May Patterson
Team Leader - Resource Assessments
NSW Department of Planning and Environment

Comments on Sutton Forest Quarries Pty Ltd – Environmental Impact Assessment

Figure 12 Hydrogeological Conceptual Model
(after Coffey, 2016)

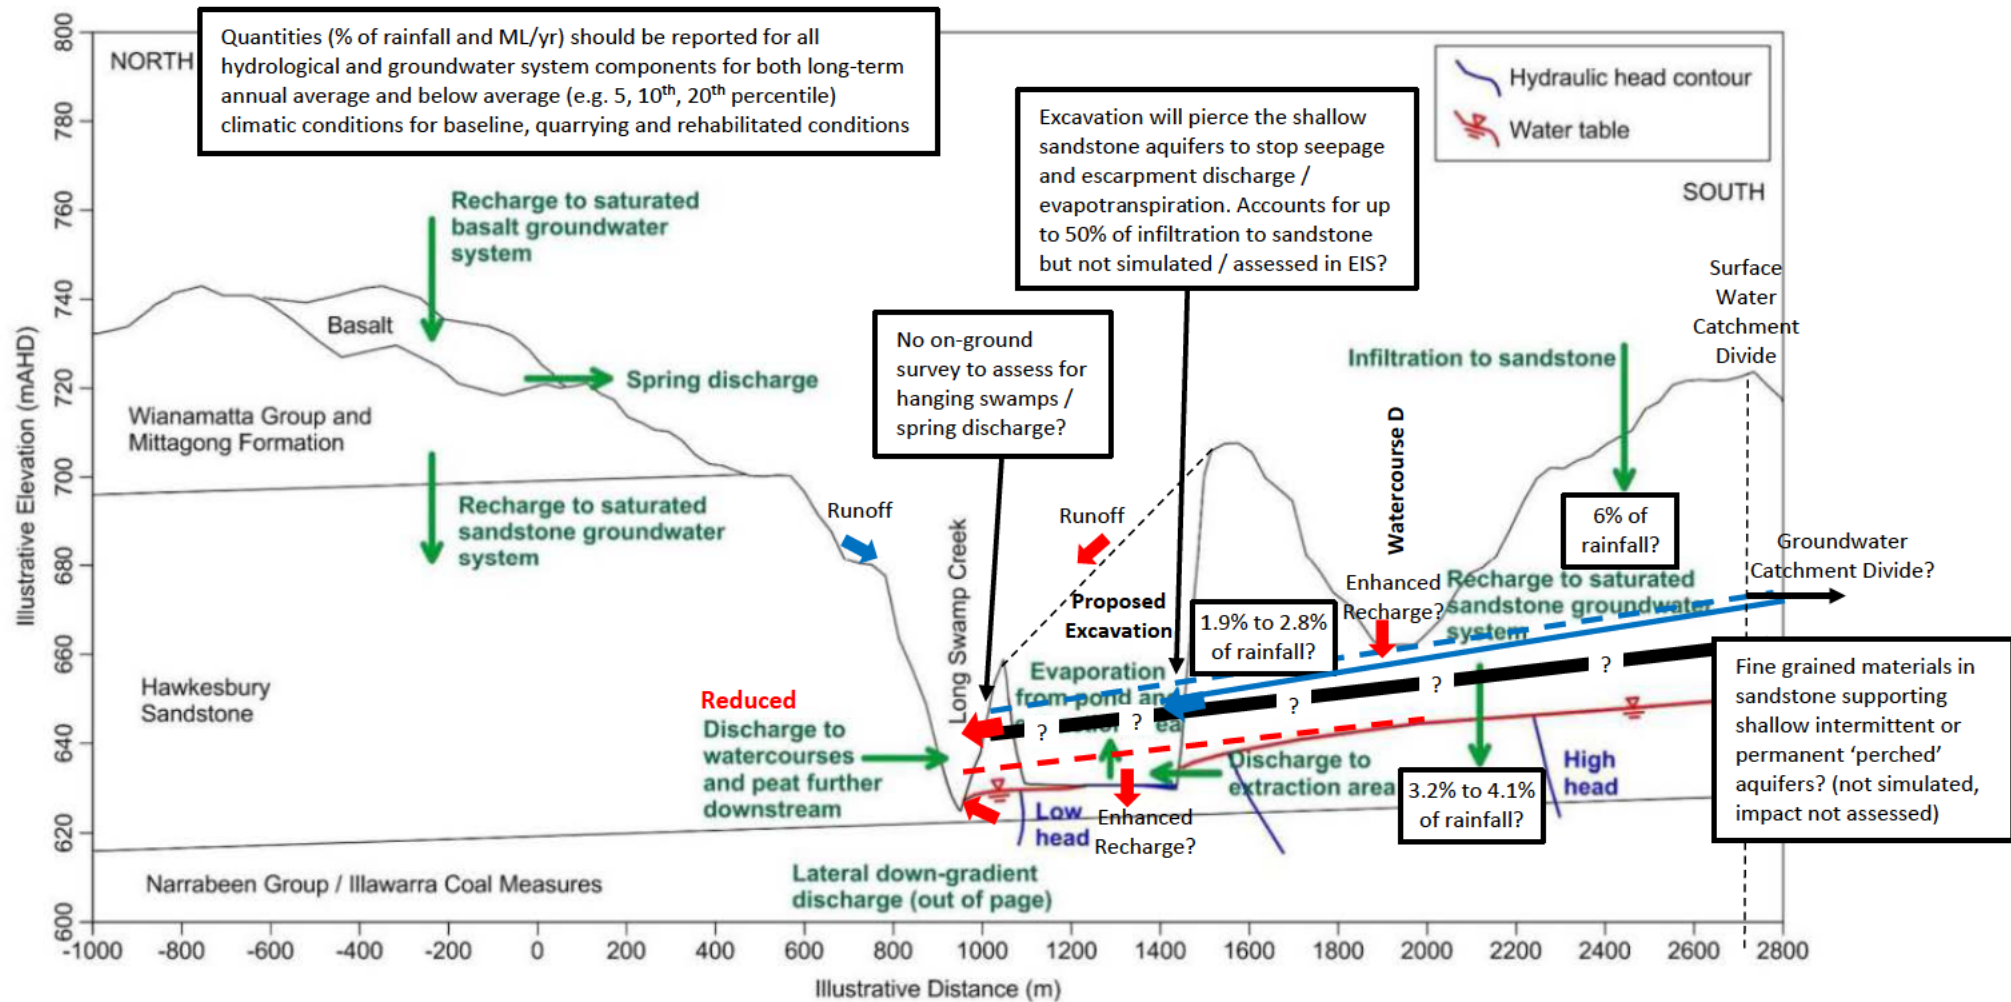
Minor Problem: Modellers assume no groundwater flow across surface water catchment divides, even despite the presence of groundwater pumping wells outside and near the chosen model boundary. The model calibration and cumulative impact assessment will therefore exclude the impact of these wells on baseflows to Long Swamp Creek. Consequently, the model calibration process results in different, surrogate values of recharge and hydraulic to reproduce observed heads and offset the groundwater capture that excluded from the simulation.

Appendix D: Numerical Model Domain Recommendation

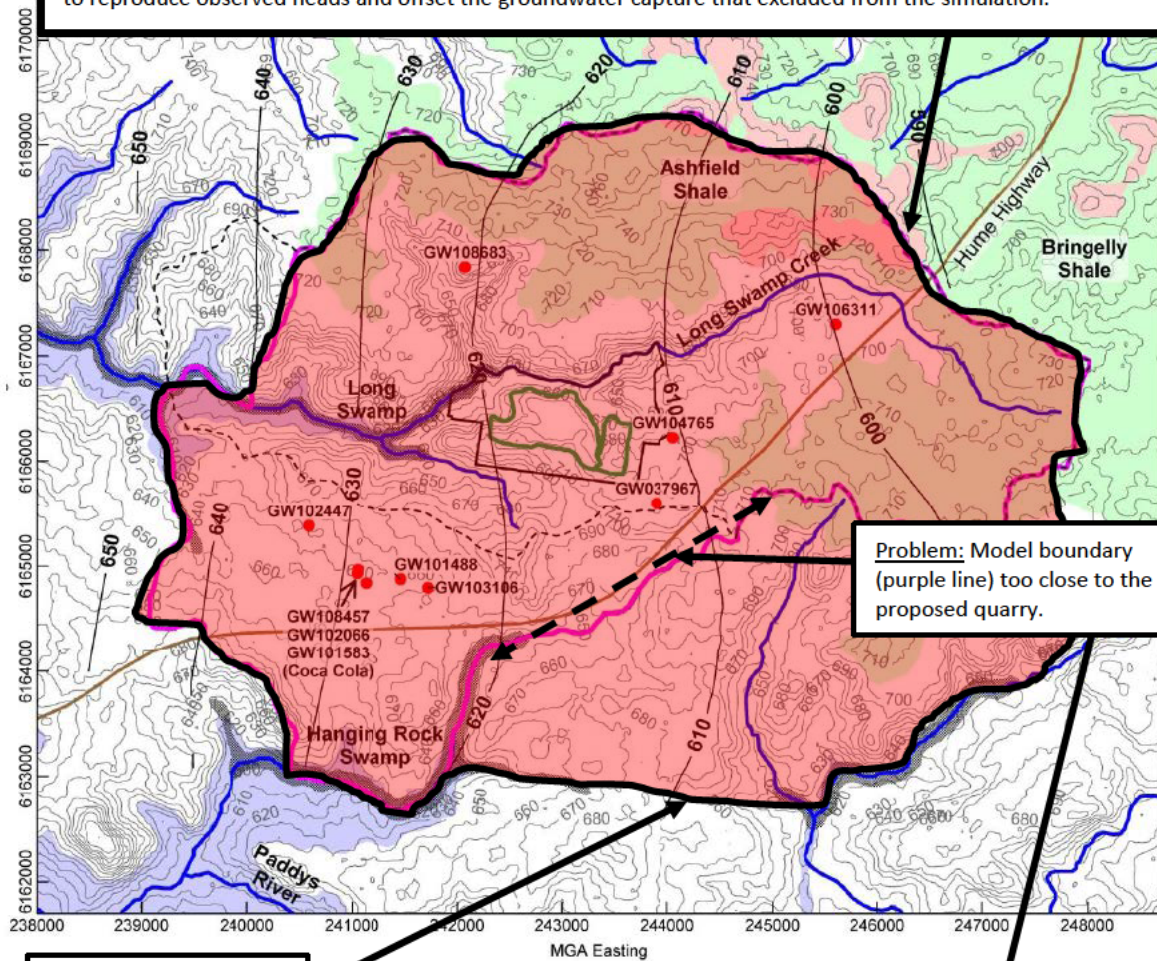
9. Groundwater capture by the proposed quarry is predicted to extend southwards into neighbouring catchments beyond the extent of the numerical model domain. For example, note how in Figure 23 on page 2-72 of Cook (2018) the 0.1m drawdown contour predicted by Coffey (2016) abuts the southern model boundary. Therefore, the model domain should be revised to assess the potential baseflow impacts to Stingray Swamp and/or Hanging Rock Swamp. The EIS should clearly report the cumulative impact of all quarrying and nearby groundwater pumping activity on all EECs. Refer to Appendix D for illustration.
